STAFF REPORT

FILE NUMBER: 247-21-001111-SP

REQUEST: Site Plan review for 70 Overnight Lodging Units (OLUs) in the
Thornburgh Destination Resort.

Figure 9 - Proposed Parking Location for Nature Villa OLUs

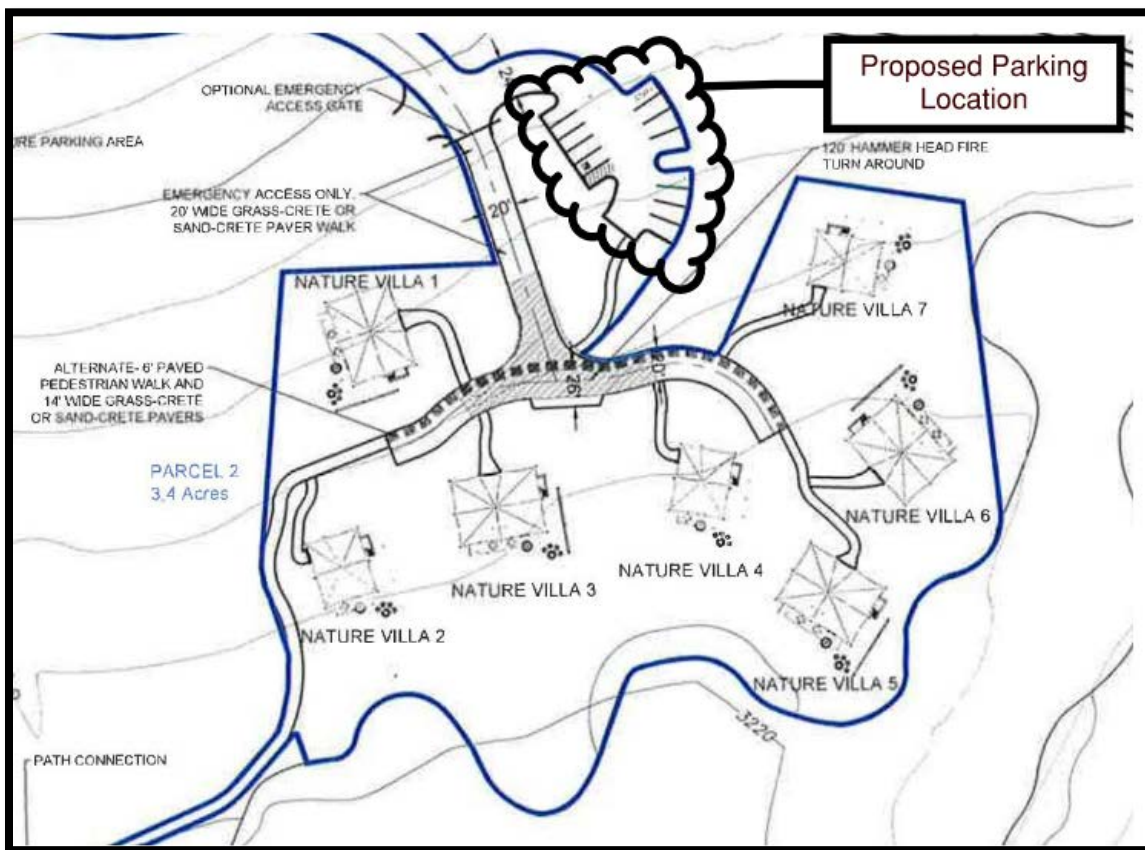
Staff finds the proposed parking spaces for the Nature Villa OLUs are not adjacent to each OLU structure (see *Figure 9* below). The Applicant's incomplete letter response, dated March 1, 2022, appears to acknowledge this discrepancy with the following response:

Staff asks the Hearings Officer to make specific findings on whether all of the requirements of FMP Condition 33 are met.

Figure 10 – FMP Open Space Plan (Exhibit A.1.1)

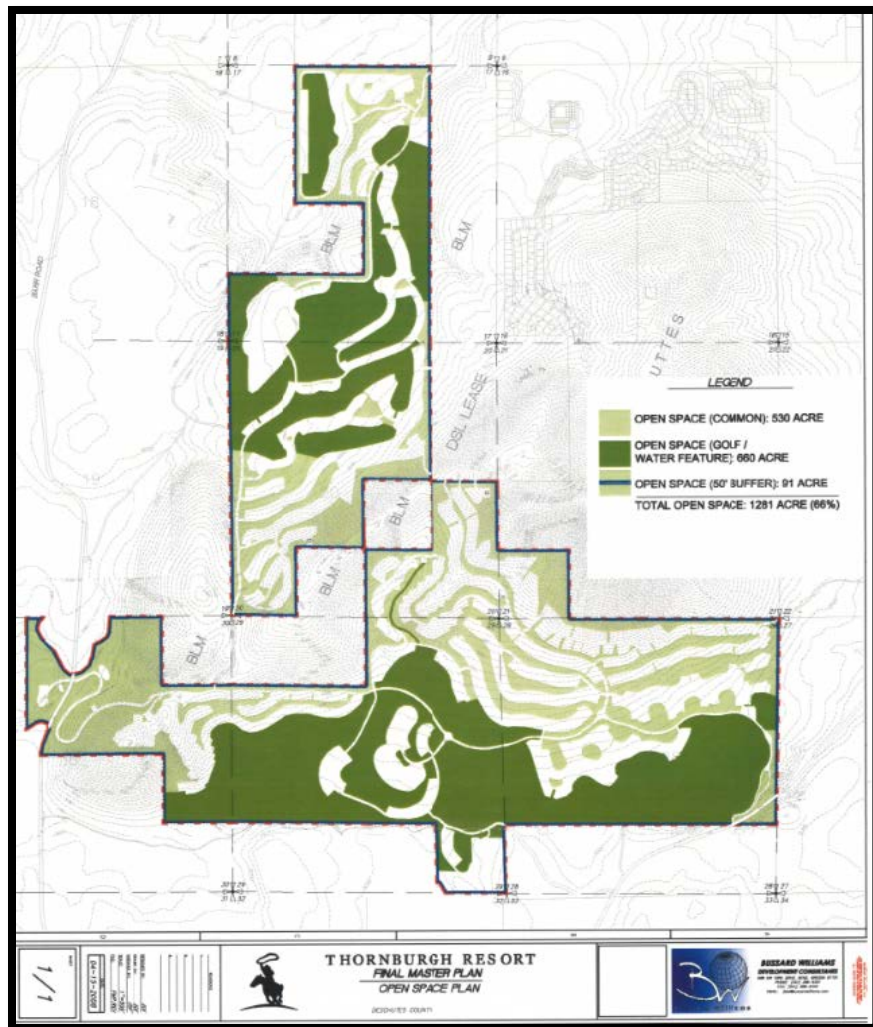
Figure 10 and Figure 11 below show the open space areas approved as part of the FMP. The proposed OLU site plans appear to be located in areas identified as open space areas on these maps. Staff recommends a condition of approval to ensure compliance.

Open Space Area Restoration. Where construction disturbs native vegetation in open space areas that are to be retained in substantially natural condition, Applicant shall restore the native vegetation. This requirement shall not apply to land that is improved for recreational uses, such as golf courses, hiking or nature trails or equestrian or bicycle paths.

Figure 14 -Village Cabin Overflow Parking Spaces

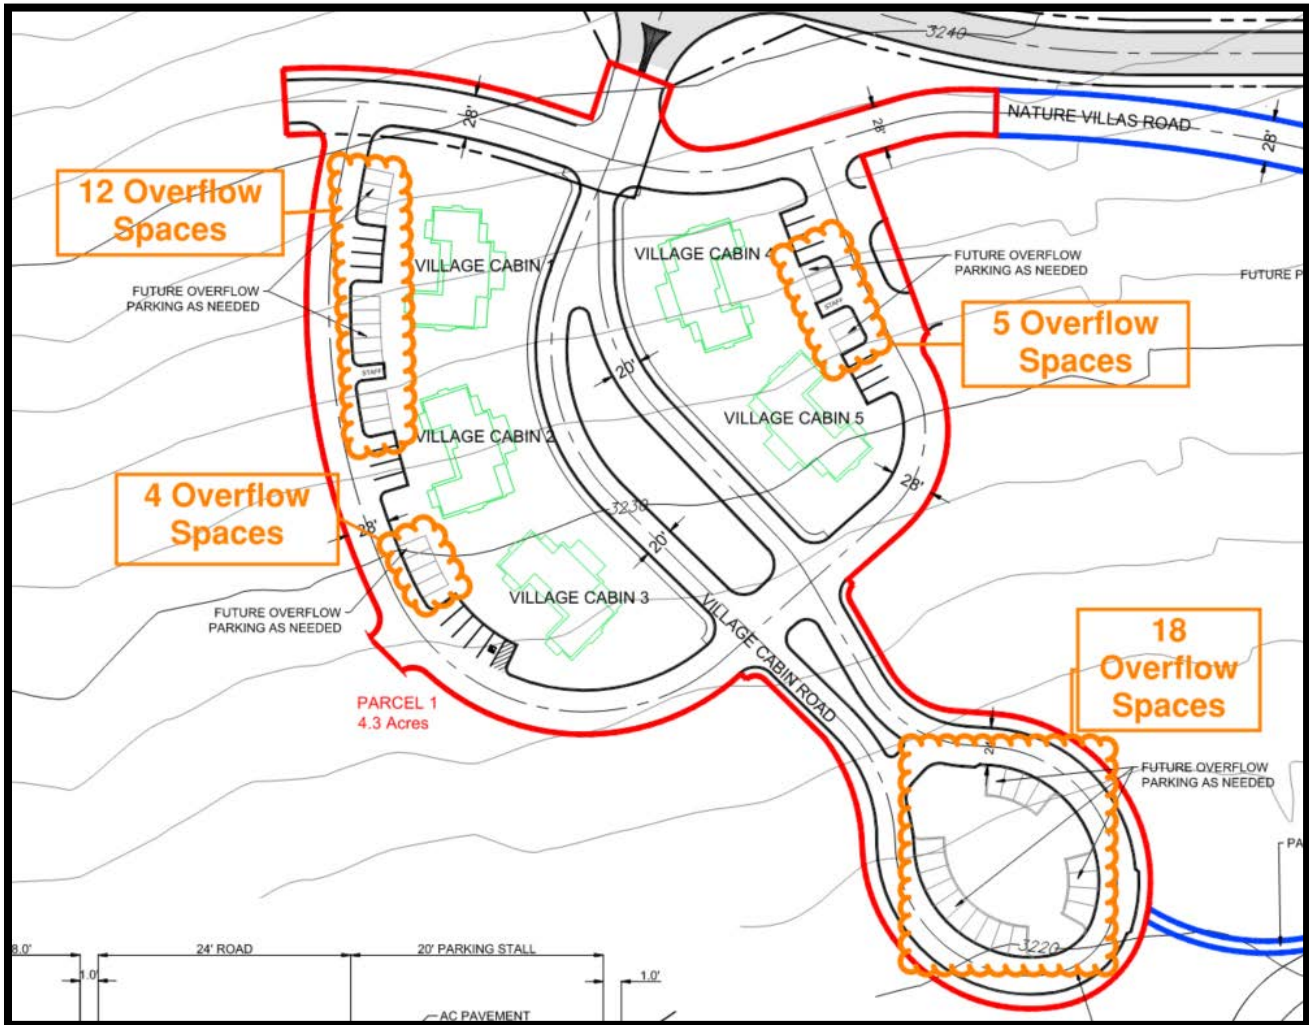
In addition to the required parking, it appears the applicant may be requesting approval for several

overflow parking areas for the Village Cabin OLU use. The submitted site plan shows a total of 39 overflow parking spaces (see *Figure 14* below). Staff notes no explanation was provided by the Applicant regarding why this amount of overflow parking is necessary for the Village Cabin OLU, but not the other proposed OLUs. For this reason, it is unclear if these parking spaces are intended to be used in association with other, future, uses of the resort. Staff asks the Hearings Officer to make specific findings on what parking spaces are included in this review.

Figure 15 - Distance of Southern Overflow Parking from Closest OLUs

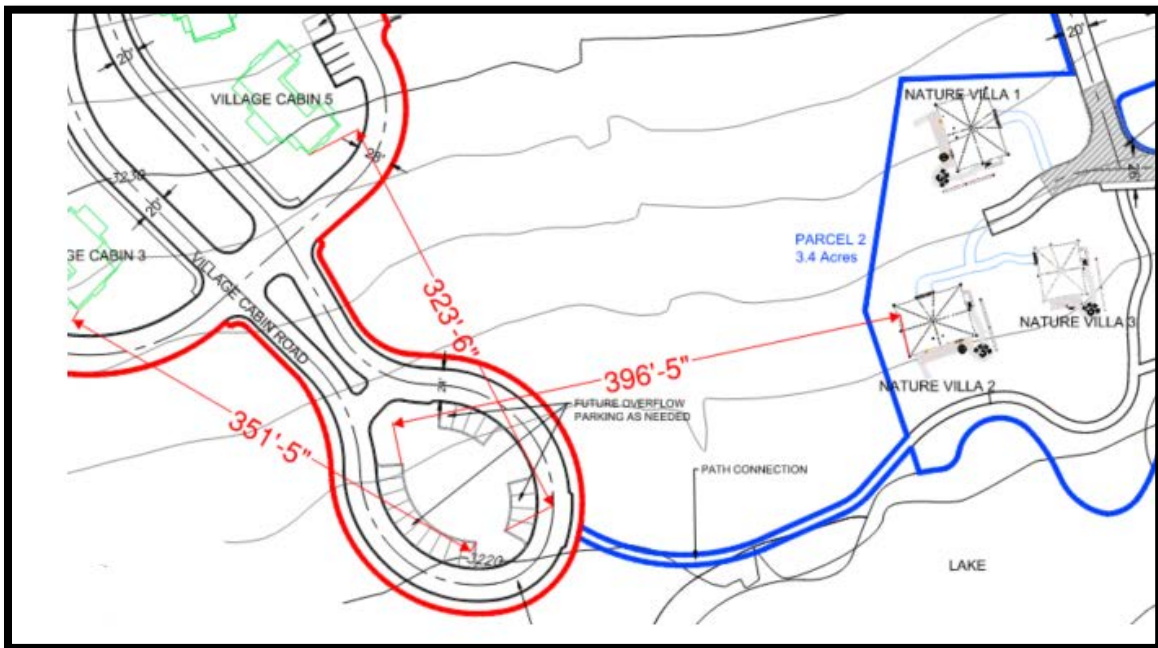
Based on this response, it appears the Applicant plans to submit future Site Plan review applications for other facilities located in the Village Cabin area. Based on this response, staff finds no joint use parking is proposed at this time.

Figure 17 – Nature Villa Single OLU Bicycle Parking Location

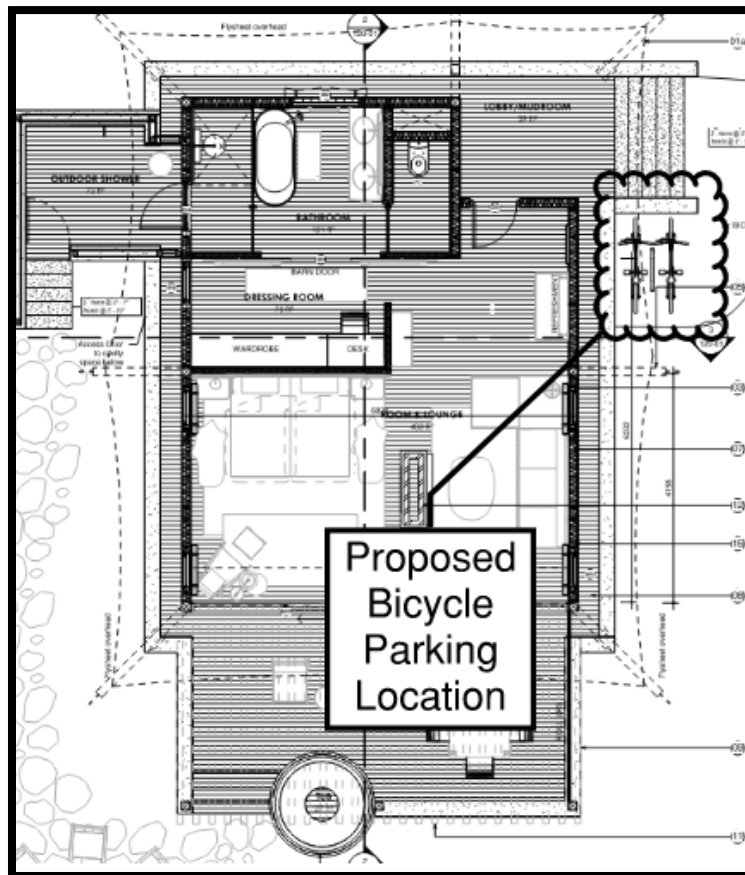
FINDING: Staff finds the proposed sheltered bicycle parking shown on sheets BP-11 and BP-13 do not comply with these criteria (see *Figure 17* and *Figure 17* below). The reference drawings shows this parking is only partially under a “decorative PVC flysheet”. Additionally, staff finds the proposed sheltered bicycle parking shown on sheets BP-1 and BP-9 are not fully covered. Staff asks the Hearings Officer to verify if the proposed bicycle parking complies with these criteria.

Figure 19 - Phase A-1 Tentative Plan Drawing

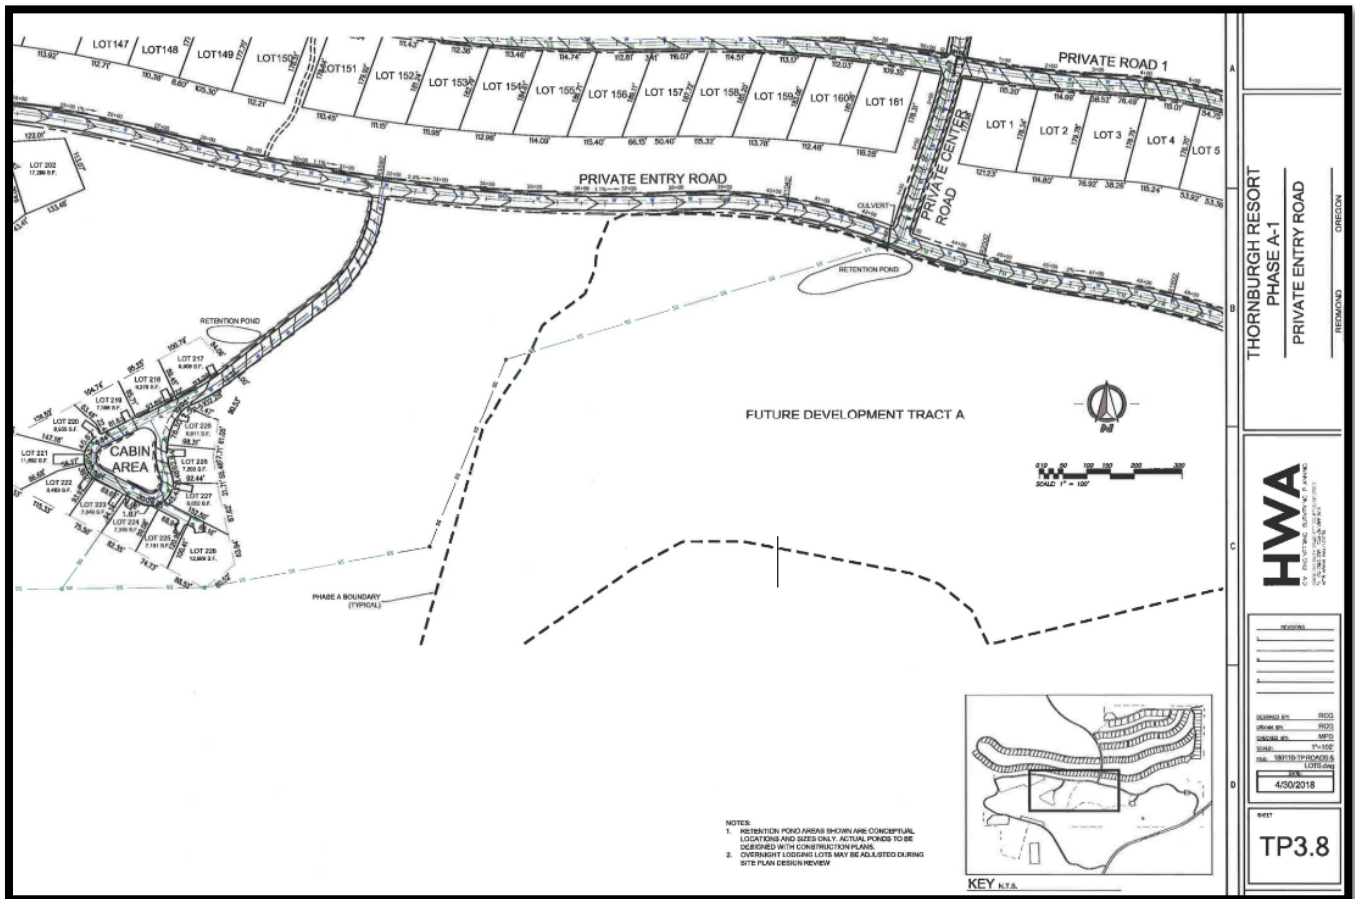
Staff finds only the access point and street layout for the proposed Golf Course Cabin OLU's was evaluated under the Phase A-1 Tentative Plan approval. As shown in Figure 19 below, the proposed development area for the Village Cabin OLU's and Nature Villa OLU's is identified as a "Future Development Tract A" and this figure clearly shows this area is not located within the "Phase A Boundary".

Staff finds the proposed roads and alleys shown on the Village Cabin OLU's and Nature Villa OLU's have not been reviewed as part of a Tentative Plat approval. Therefore, it is unclear to staff if the proposed roads and alley meet all of the applicable design requirements of DCC Title 17. Additionally, it does not appear the proposed alley access to Golf Cabin Lots 224-227 has been approved by the County.

The Applicant's proposal shows Village Cabin Road will extend more than 300 feet beyond the location of the proposed OLU's. Staff finds this proposed street segment is not necessary to serve the proposed OLU's and will disturb additional native vegetation on the site. Staff notes Sheet C6.0 shows the proposed road network adjacent to the proposed Village Cabin OLU's has the necessary

Figure 20 – Phase A-2 Tentative Plan Drawing

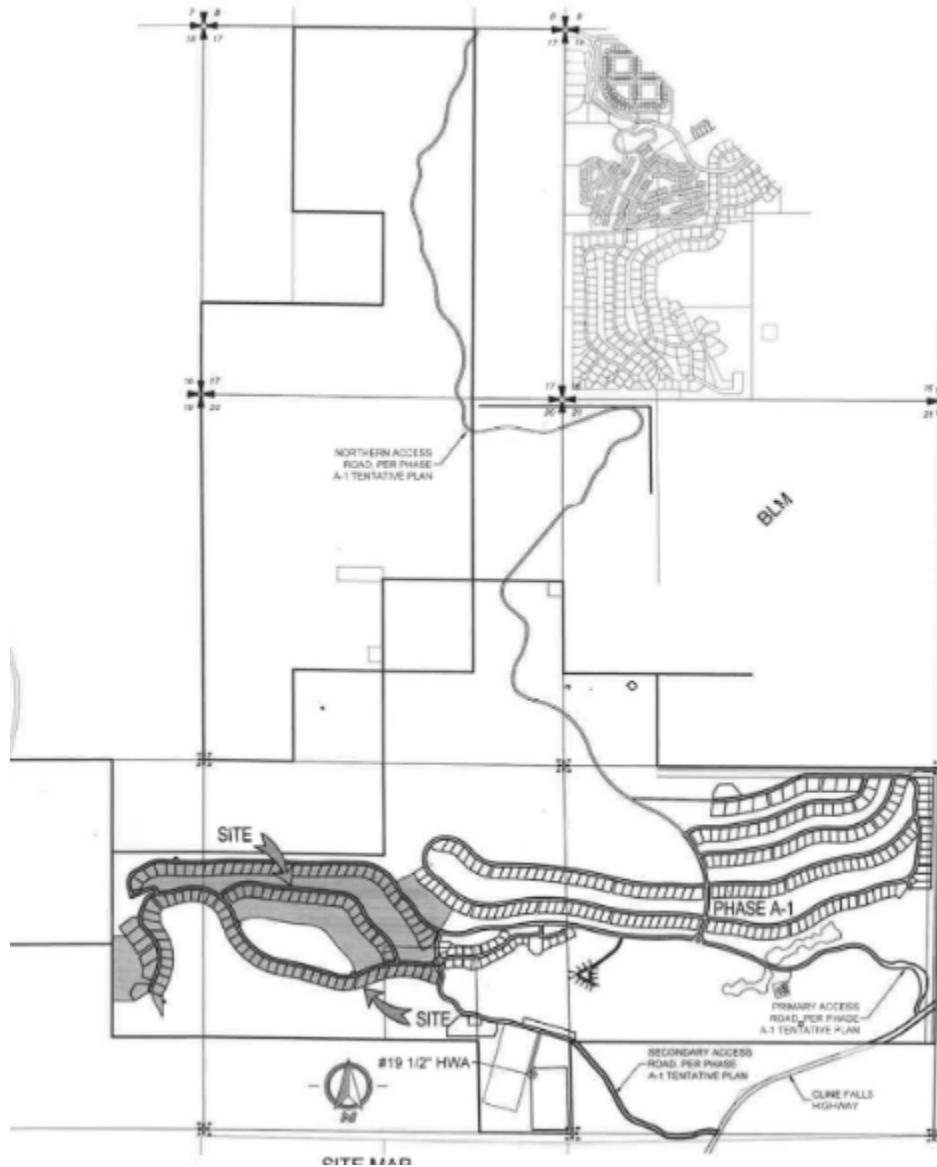
Staff finds the roads serving the Golf Cabins OLUs were reviewed under Tentative Plan A-1. However, the A-2 Tentative Plan approval did not include any areas within the proposed OLU development areas and the relevance of this review, as part of the current proposal, is unclear (see Figure 20 below). Staff finds the proposed Village Cabin Road and Nature Villas Road have not been

reviewed as part of a Tentative Plan approval and do not appear to be laid out as shown on the FMP Master Development Plan. For these reasons, staff believes the applicant has not obtained the necessary approvals from the County to establish these roads as the County has not been afforded an opportunity to review and identify required sight distance, turn and acceleration/deceleration lanes, right-of-way, roadway surfacing and widening, or bicycle and pedestrian connections. Staff asks the Hearings Officer to make specific findings on this issue.
